MEMO FROM COUNCIL OFFICE:

Re: Ordinance 2024-07 - To Amend the City of Bloomington Zoning Maps by Rezoning A 138.51 Acre Property From Planned Unit Development (PUD) And Residential Medium Lot (R2) to Planned Unit Development (PUD) And to Approve a District Ordinance and Preliminary Plan – Re: S. Weimer Road (Sudbury Partners LLC, Petitioner)

Ordinance 2024-07 would rezone a 138.51 acre property from Planned Unit Development (PUD) and Residential Medium Lot (R2) to a Planned Unit Development (PUD) and approve a PUD District Ordinance and Preliminary Plan.

Figure 1. Summit District PUD nearby streets. Red circles are anticipated choke points.

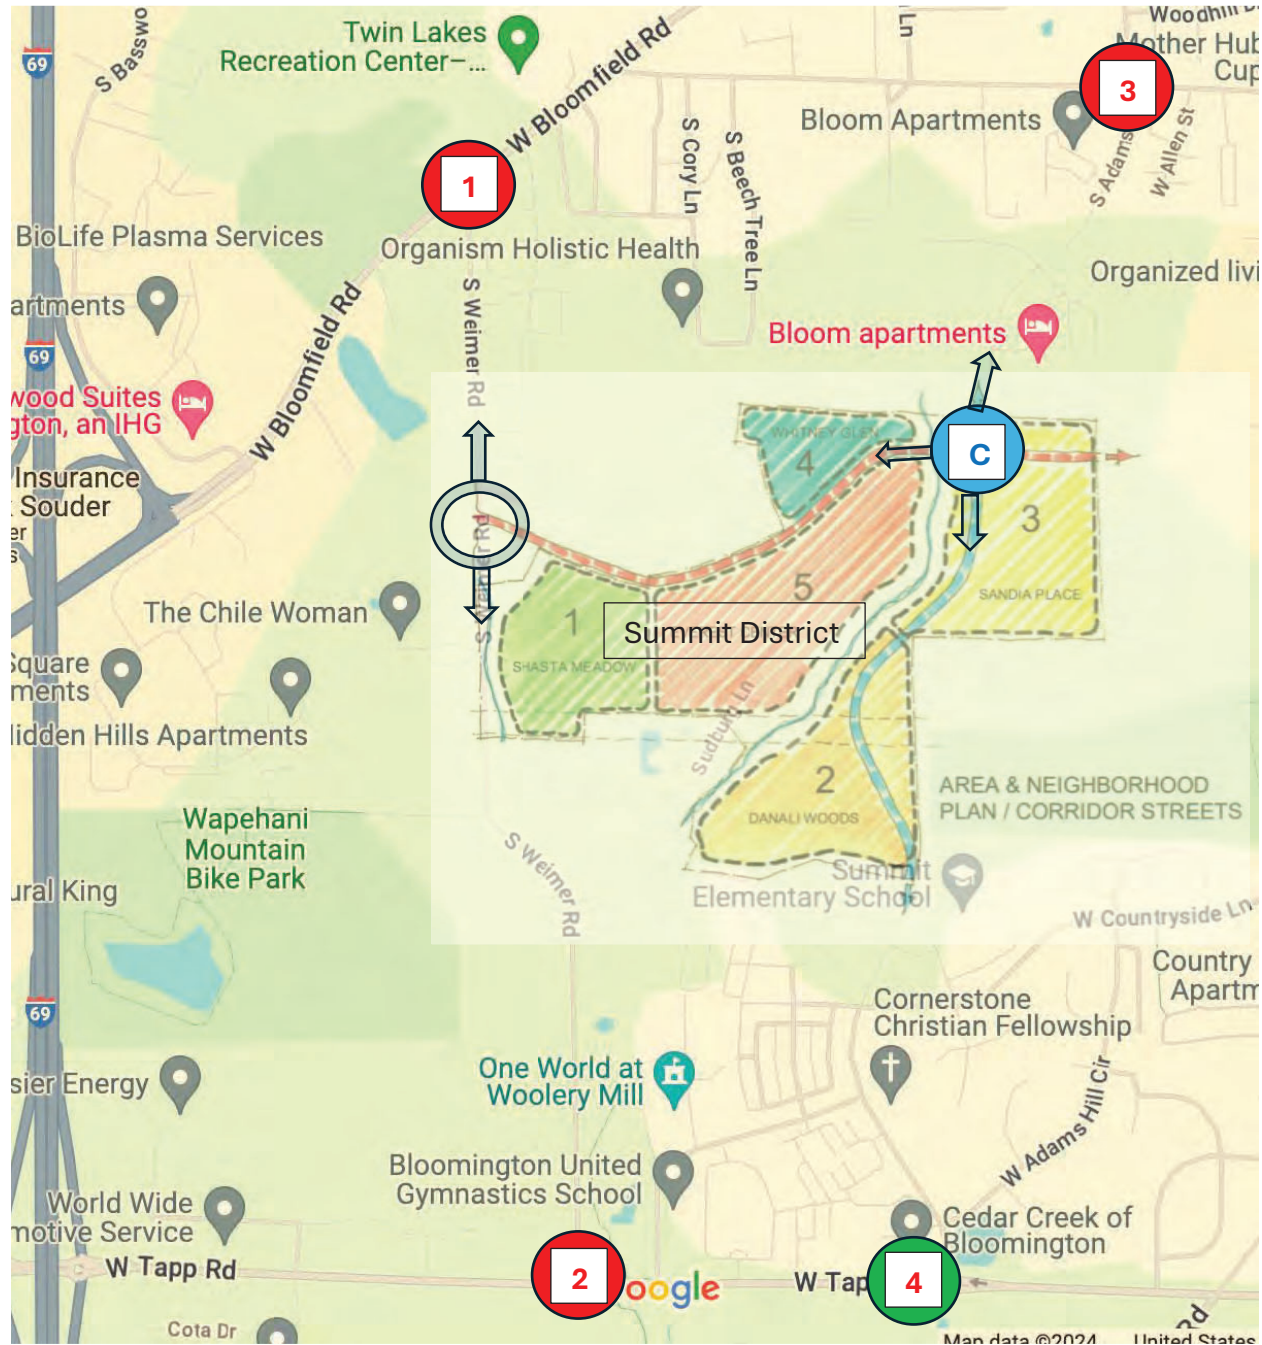
great as the city of Martinsville. While these are ballpark estimates, they do put things into perspective, as Table 1 shows. And this will impact traffic congestion, because currently there are only 4 main ways to get in or out of the Summit PUD area to nearby main arterials (Tapp Rd. and Bloomfield Rd.). Note that S. Adams intersects with W. 2nd St where there is currently a stoplight, which is north of the Adams and Allen St. intersection at circle 3.

Image A. COBERI Figure 5 of subterranean karst in southwest Bloomington in 2003. Text boxes added for intersections of Weimer Rd. and W. 2nd St. (Bloomfield Rd.), for Weimer Rd. and Tapp Rd., and for the former Weimer Lake.

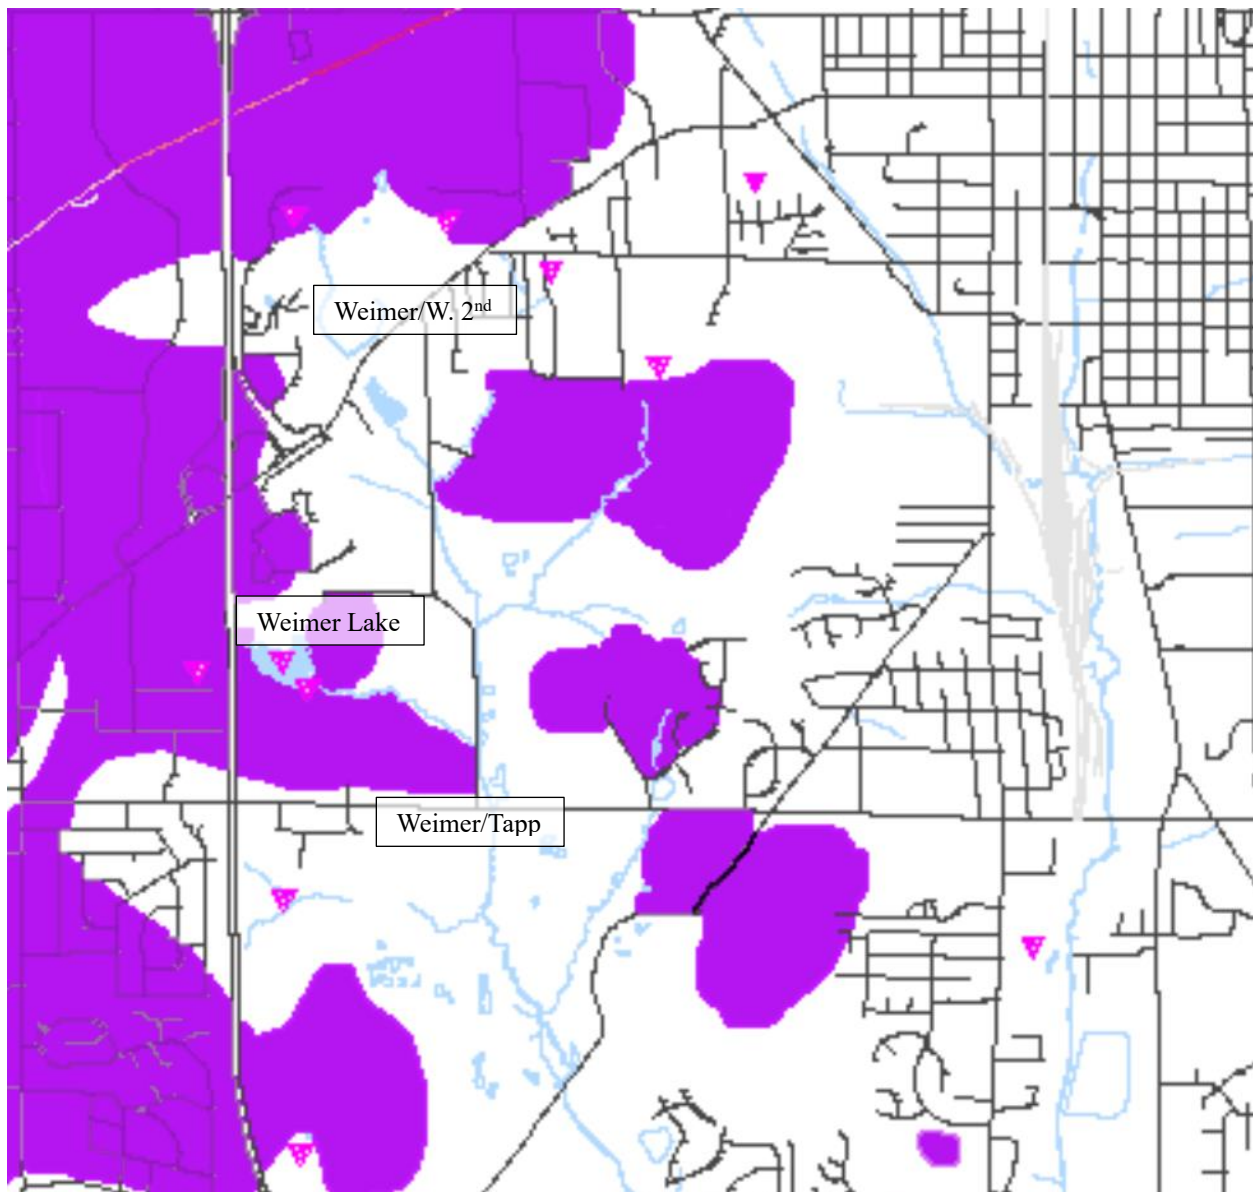
A number of sinkholes were reportedly located within the PUD, especially at the higher elevations of the Summit District. See Stantec's Environmental Constraints report in the BPC meeting packet: https://bloomington.in.gov/onboard/meetingFiles/download?meetingFile_id=13177. It is evident in map EX-8 (p. 107) that bedrock is typically 3 to 5 feet below the surface in much of the PUD area in the higher elevations, and Image A* indicates that this is mostly karst. Although the Summit District PUD indicates preservation and protection of 48 existing sinkholes identified in EX-8, **the fact remains that much of the development would be on top of or may need to cut into existing karst bedrock identified in the COBERI and Stantec reports.**
